**PERMIT  
 INDEXED  
 TAX ID #05-342384  
 ON-SITE SEWAGE DISPOSAL SYSTEM  
 HOWARD COUNTY HEALTH DEPARTMENT  
 BUREAU OF ENVIRONMENTAL HEALTH**

SUBDIVISION: Mooresfield LOT NUMBER: 10, Sec 4

ADDRESS: 4717 Cherry Tree Drive PROPERTY OWNER: William Pawlak Robert SURRETTE  
 Theron Ames

Subject:- variance request.

**HOUSE LOCATION SURVEY**  
 # 7417 CHERRY TREE DRIVE  
 LOT 10  
 MOORESFIELD SECTION 4  
 PLAT BOOK 10 ; PG. 65

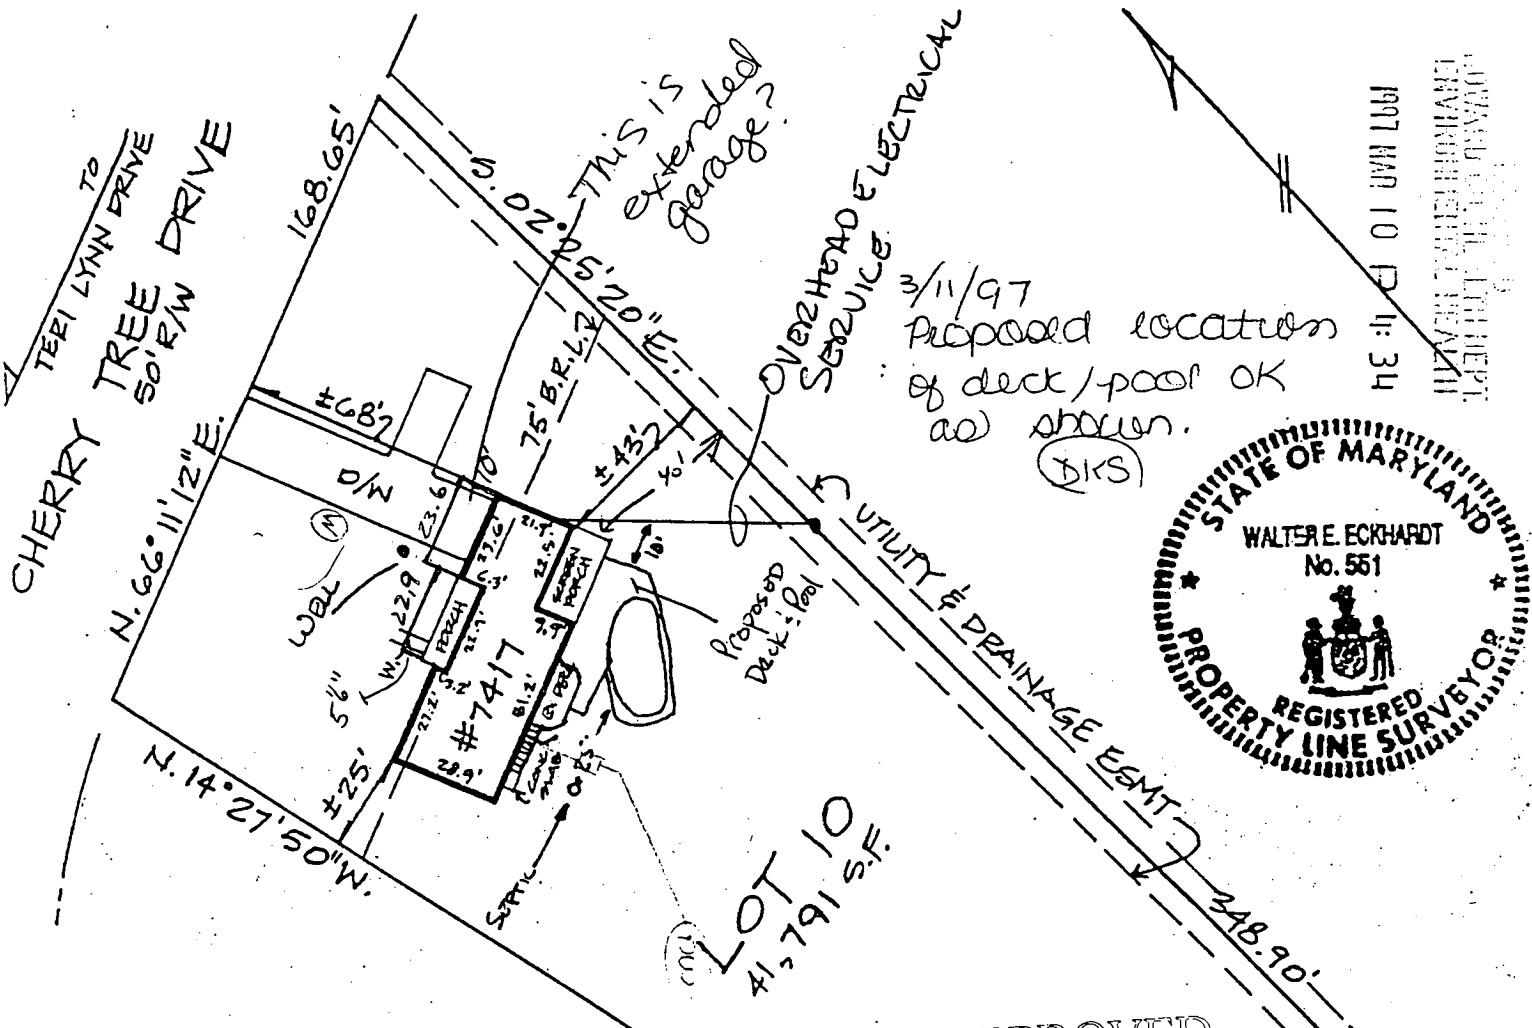
**APPROVED**  
**WALK-THRU BUILDING PERMIT**  
 RP# 0015 3462 A# 5885  
 APP SAN Kace DATE 6/22/05  
 DESC OF WORK: Various garage extensions & porch

LOCATION DIAGRAM

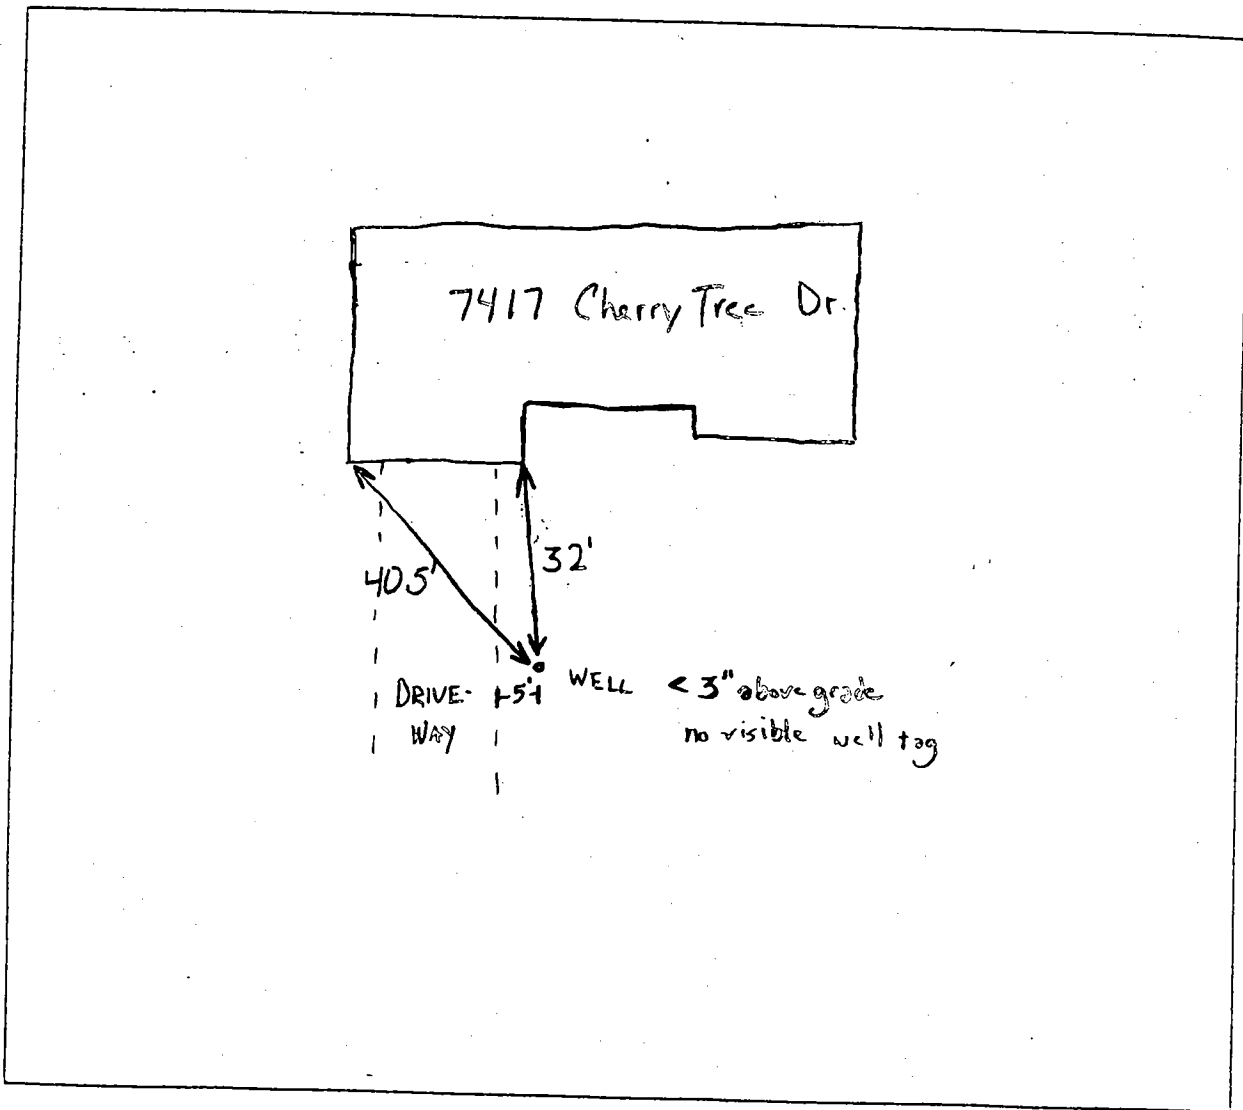
OWNER: \_\_\_\_\_ PHONE #: \_\_\_\_\_  
ADDRESS: 7417 Cherry Tree Dr CONTRACTOR: \_\_\_\_\_  
\_\_\_\_\_ WELL TAG #: ?  
SUBDIVISION: \_\_\_\_\_ LOT: \_\_\_\_\_ COUNTY #: \_\_\_\_\_  
PROPOSAL: BP - Need to verify well loc

COMMENTS: Well is not up to code - 3" above grade no visible tag.  
6/24/05 letter sent about water testing  
should be done. Next permit will require  
getting well up to code (K)  
DATE: 6/22/05 INSPECTOR: GL & BB
